VA Roseburg - Community Living Center Expansion – Project No: 653-321  
913 NW Garden Valley Boulevard  
Roseburg, OR 97471

## ADDENDUM NO. 2

This Addendum forms a part of the Contract Documents and modifies the original Bidding Documents (Conformed Set) dated March 15, 2012 as noted below. Acknowledge receipt of this Addendum in the space provided on the Bid Form. Failure to do so may subject the Bidder to disqualification.

# AD-02 FLOOR PLAN - POWER

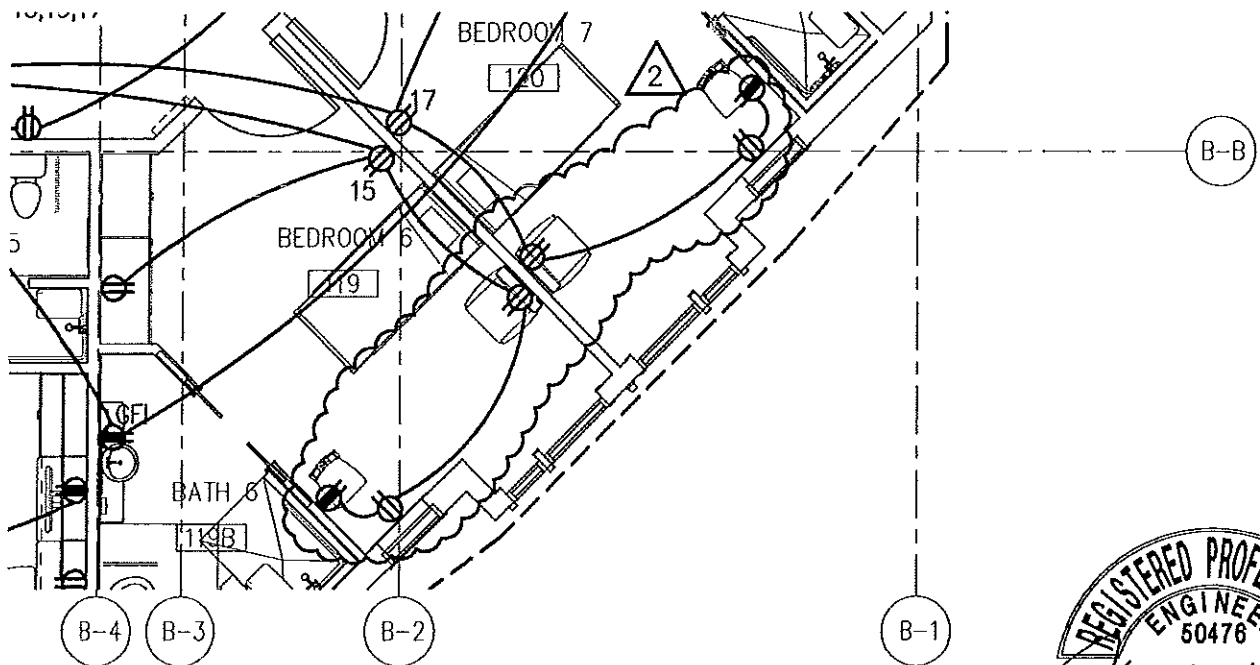
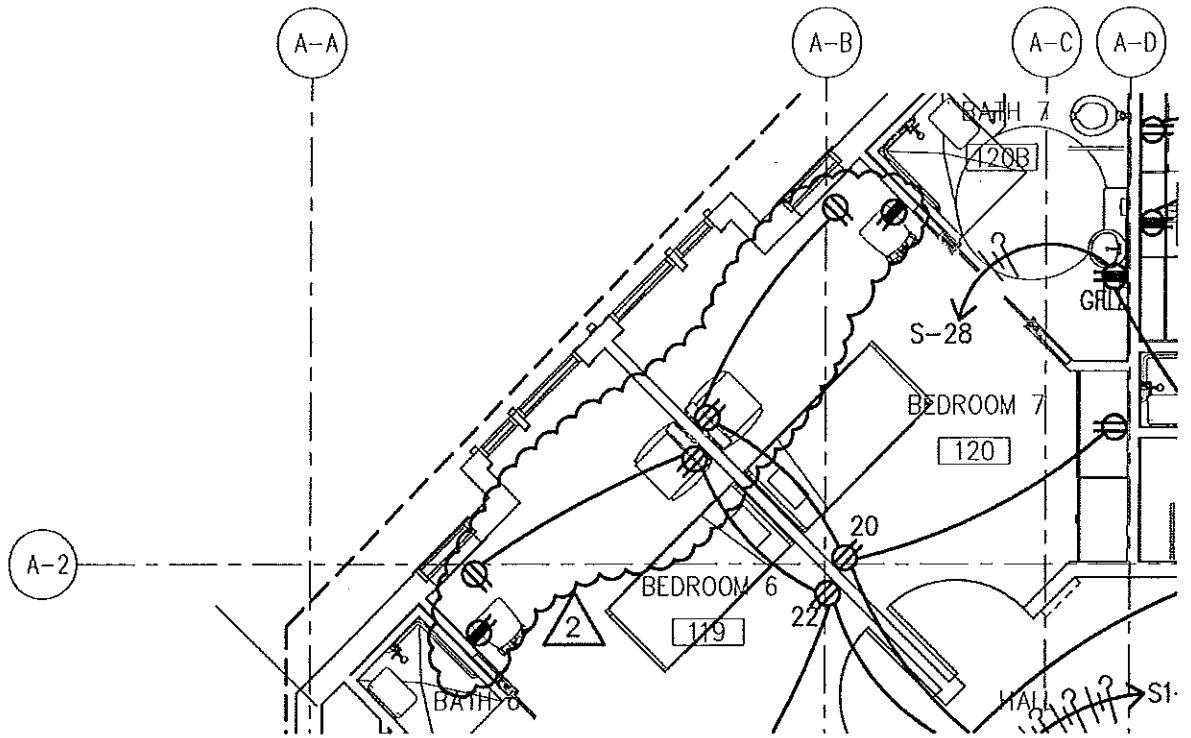
- A. Add electrical outlets in Bariatric Rooms (Room #6,7 in both wings) as shown on attached sheet AD2.01.

# FIRST FLOOR PLAN - LIGHTING

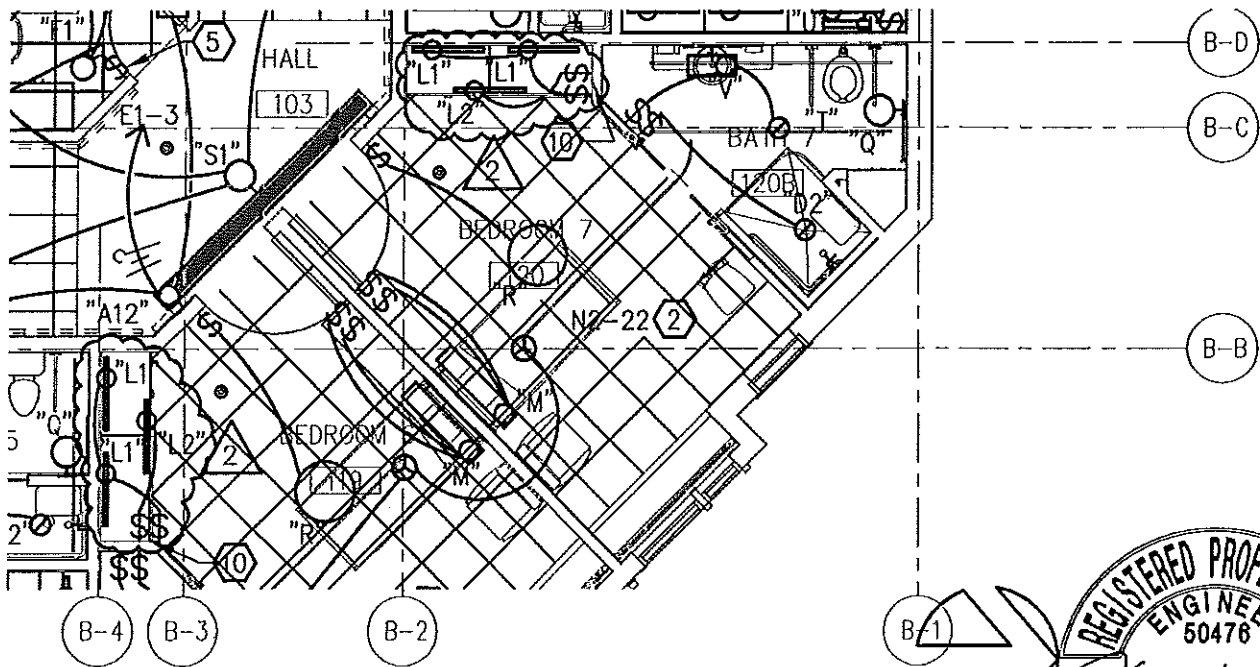
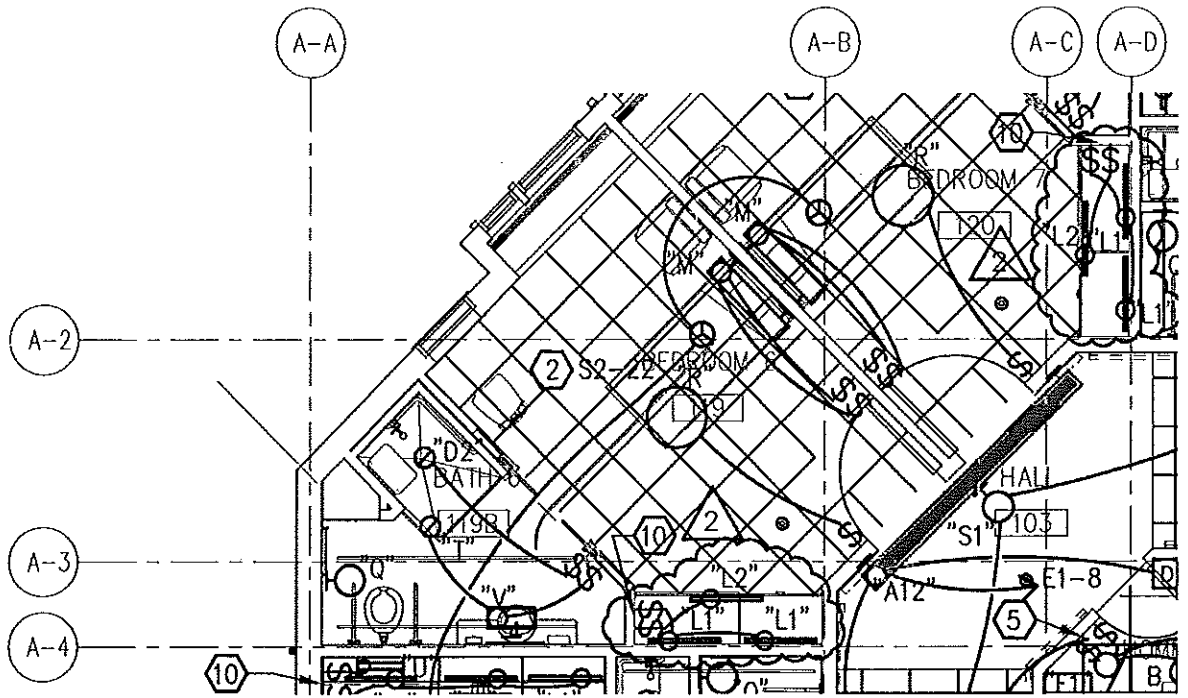
- A. Delete fixture type U in all Bariatric Rooms (Room #6,7 in both wings) as shown on attached sheet AD2.02.
- B. Add fixture type L2 in all Bariatric Room (Room #6,7 in both wings) as shown on attached sheet AD2.02.
- C. Delete fixture "S2" on the exterior angled wall between Activity Room 106 & Dining Room 108 in both Unit A & Unit B.

# FLOOR PLAN - TELECOM

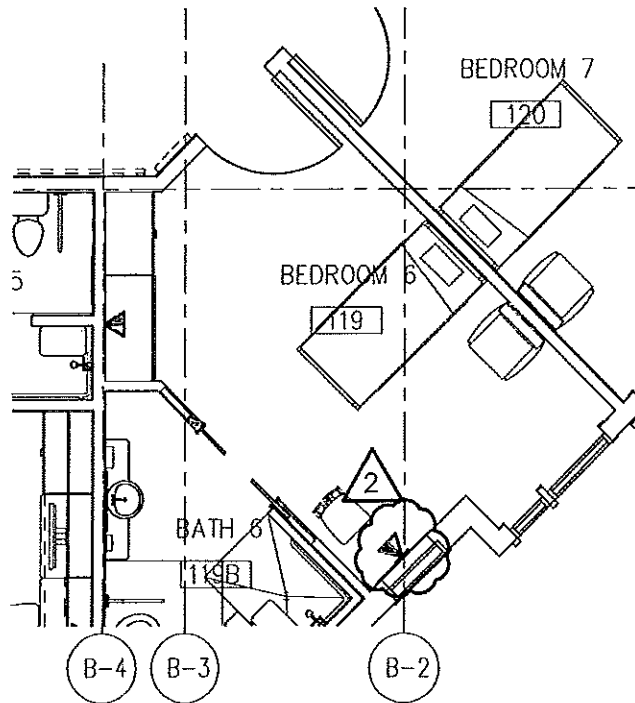
- A. Add data outlet at desk area of all Bariatric Rooms (Room #6,7 in both wings). See attached sheet AD2.03 for typical location of outlet.
- B. Add the following General Note #1: Provide two(2) Cat 6 cables at all data locations except for home office. Provide three (3) Cat 6 cables at data locations in Home Office.

# FLOOR PLAN - SIGNAL/NURSE CALL

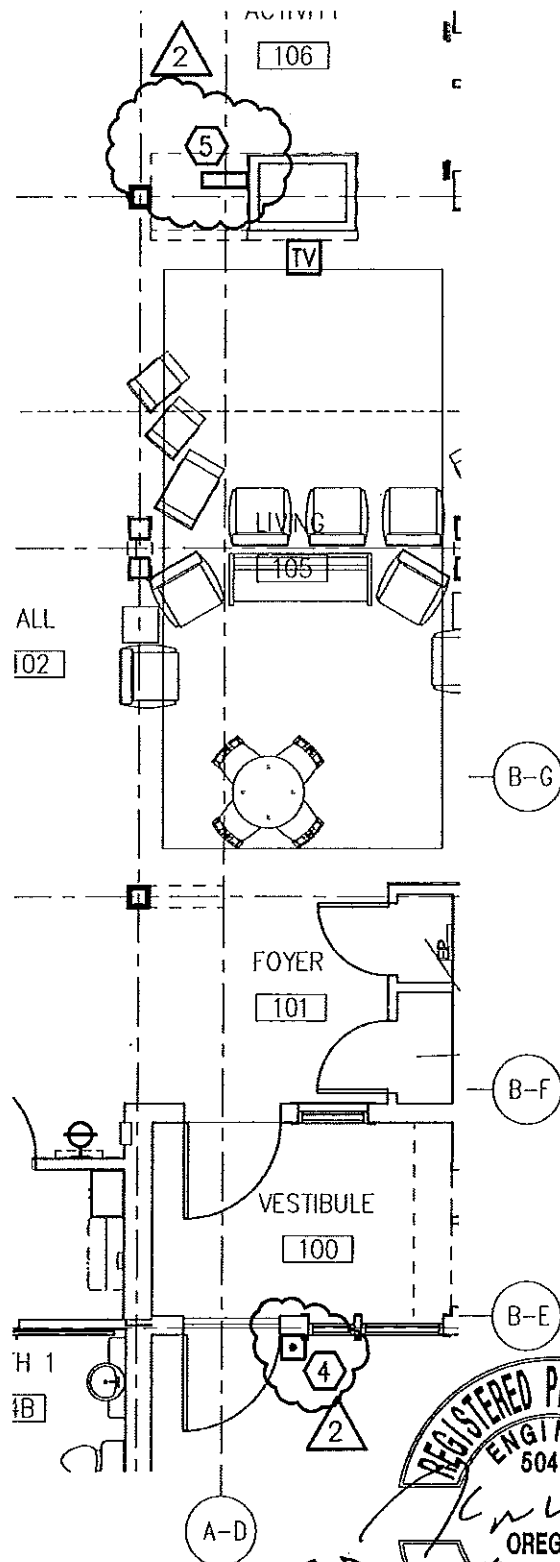
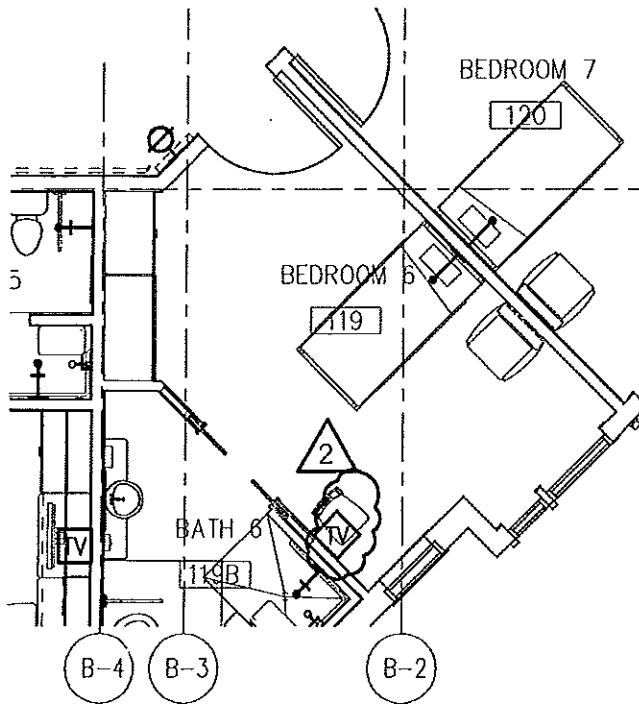
- A. Add TV outlet in all Bariatric Rooms (Room #6,7 in both wings). See attached sheet AD2.04 for typical location of outlet.
- B. Add door bell and chime in both wings. See attached sheet for typical location of door bell and chime. Provide at each wing.
- C. Add TV outlet on west wall of Salon C101.
- D. Add the following General Note  
"1. BASE OF DESIGN FOR TV RECESSED BOXES: LEGRAND TV1WTVSSW."

3 TYPICAL FOR ALL BEDROOM DOME LIGHTS.  
INSTALL CENTERED ABOVE MEMORY BOX.

4 DOOR BELL.

5 DOOR BELL ANNUNCIATOR INSTALL ON FACE OF  
SOFFIT.

# ELECTRICAL ONE LINE DIAGRAM - CLC

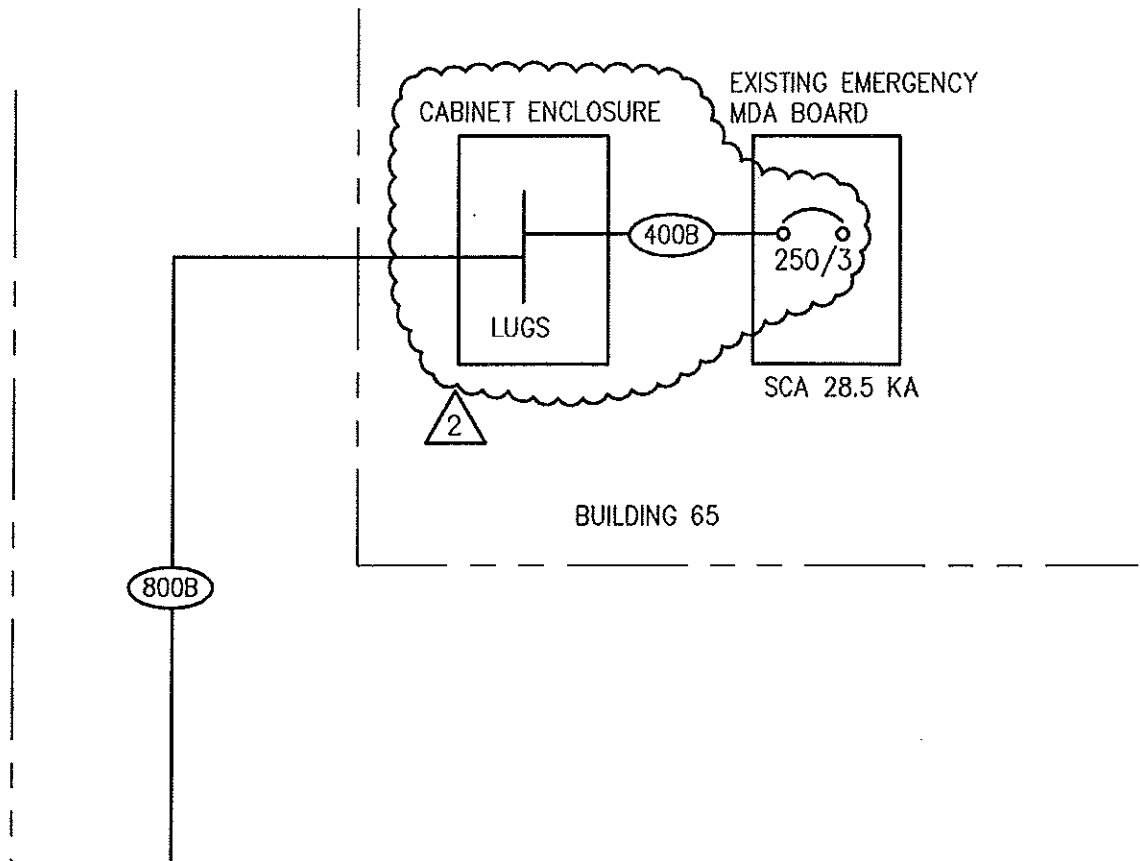
- A. Change emergency feeder as shown on attached sheet AD2.05.
- B. Add the following sheet Note #1 to normal and emergency service meters: Meter provided by electrical contractor. Refer to specifications section 25 10 10 for meter requirements.
